U.S. Department of Transportation

Refer To: HSA-CC67

In your May 30 letter you requested the Federal Highway Administration's (FHWA) acceptance of your RENCO RAM 100K truck-mounted attenuator (TMA) as a test level 3 (TL-3) device under the test and evaluation guidelines contained in the National Cooperative Highway Research Program (NCHRP) Report 350. To support your request, you sent copies of two test reports prepared by the Texas Transportation Institute (TTI), one dated July 1998 entitled "Test Level 2 Evaluation of the RENCO Ren-Gard 815 Truck Mounted Attenuator," and one dated May 2000 entitled "Summary of Testing on the RENCO Truck Mounted Attenuator." You also sent copies of a video tape showing the tests contained in the latter report.

## Figure 1. Details of the RENCO RAM 100k TMA.

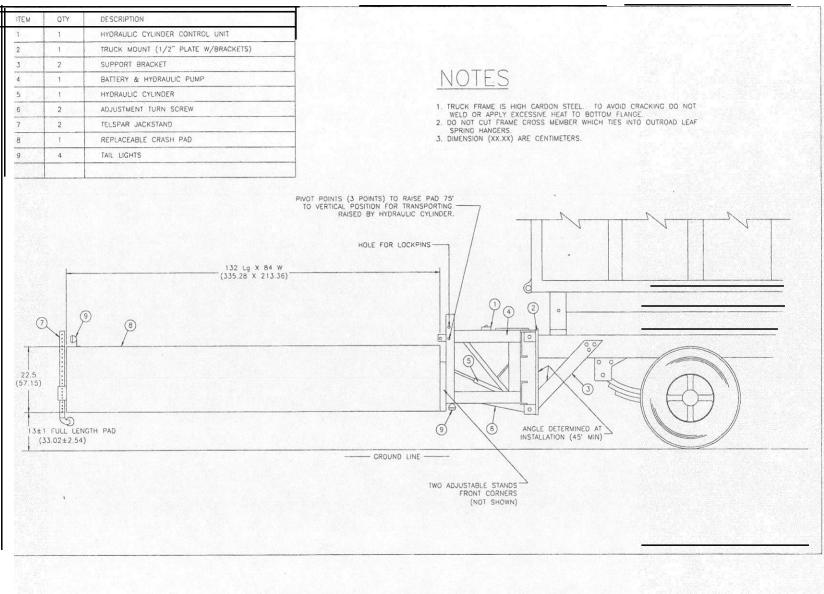
The RENCO RAM 100K TMA, as shown in Enclosure 1, is similar in construction to the TL-2 Ren-Gard 815 which was accepted (acceptance letter CC-20A) for use on the National Highway System on September 1, 1998. However, the TL-3 model is 335-cm (132-inches) long and 213-cm (84-inches) wide, compared to the 208 cm x 228 cm (82 inches x PO inches) dimensions of the TL-2 model. Both units are approximately 57 cm (22.5 inches) deep and have a ground clearance of about 33 cm (13 inches) when lowered into their operating positions. The energy-absorbing properties of both RENCO models are cardboard honeycomb sections housed in a rectangular aluminum box. The RAM 100K model itself weighs 427 kg (940 pounds) and the mounting hardware adds another 72 kg (160 pounds) to its total weight.

Figure 9. Summary of Results for test 400001-RNC6, NCHRP Report 350 test 3-50.

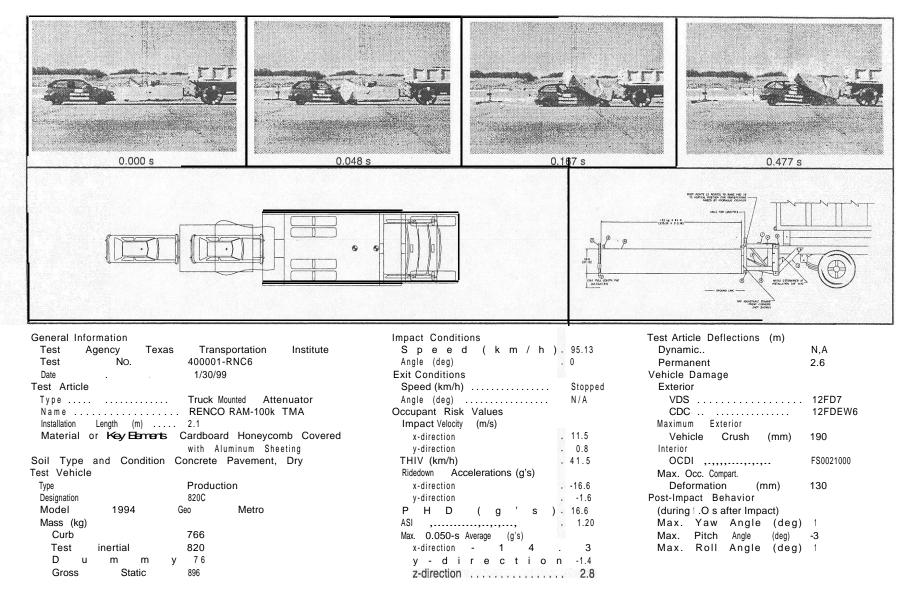
In reviewing the May 2000 TTI report, I noted that test 3-50 was run twice. In the first test (RNC6) the vehicle under-rode the TMA, resulting in some windshield damage. The occupant impact velocity (11.5 m/s) and subsequent ride-down accelerations (16.6 g's) met Report 350 evaluation criteria. A summary sheet for this test is shown as Enclosure 2. After some internal changes were made to the design, the RAM 100K was re-tested with the small car (RNC7).

- All production models of the RENCO RAM 100K TMA will be identical in internal construction and external fabrication as the prototype used in test RNC7. You will be expected to certify to users that the product furnished has the same internal and external dimensions and construction as the tested prototype.
- Users will be advised to mount the RENCO RAM 100K TMA to a support vehicle similar in weight to the 8845 kg (19,500 pound) truck used in the certification testing.
- You will establish an informal in-service evaluation system to identify any performance problems relating to vehicle under-ride as noted in test RNC6.

Figure 17. Summary of Results for test 400001-RNC7, NCH.

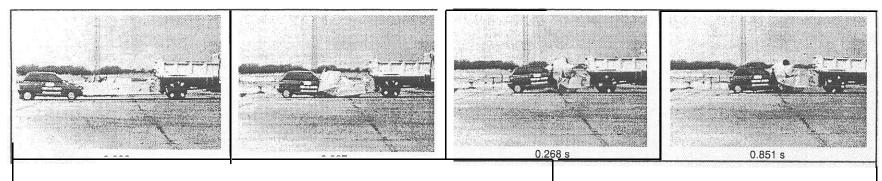
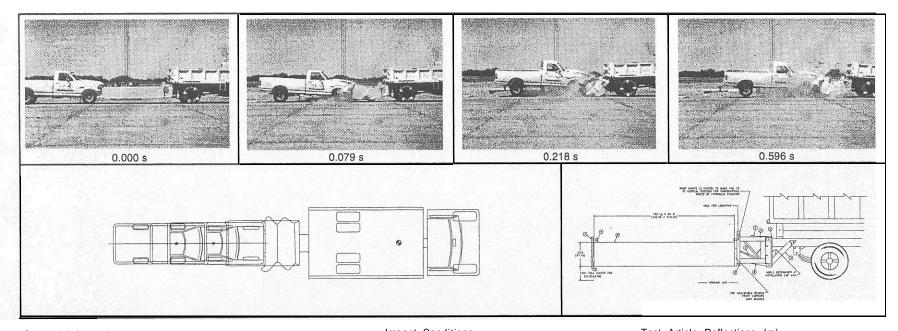
This time the vehicle under-ride was lessened, but the occupant impact velocity was 12.3 m/s, slightly higher than the 12.2 m/s that was the upper limit previously accepted by FHWA's Office of Engineering. The ride-down acceleration in the second test was lowered to 13.7 g's, Test results are summarized in Enclosure 3. Based on the results of these two tests, the authors of the TTI report concluded that the RENCO RAM 100K TMA did not satisfy all Report 350 evaluation criteria. Test 3-5 1 (RNC2) with the 2000 kg pickup truck was successfully run and is summarized in Enclosure 4. In this test, the roll-ahead distance of the support vehicle was reported to be 4.3 meters.

Although the occupant impact velocity in test RNC7 was 12.3 m/s, the FHWA, as noted above, has previously accepted at least one device having an impact velocity as high as 12.2 m/s. Since this slight difference is within measurement tolerances, I am willing to accept the RENCO RAM 100K TMA as a Report 350 TL-3 truck mounted attenuator with the following stipulations:
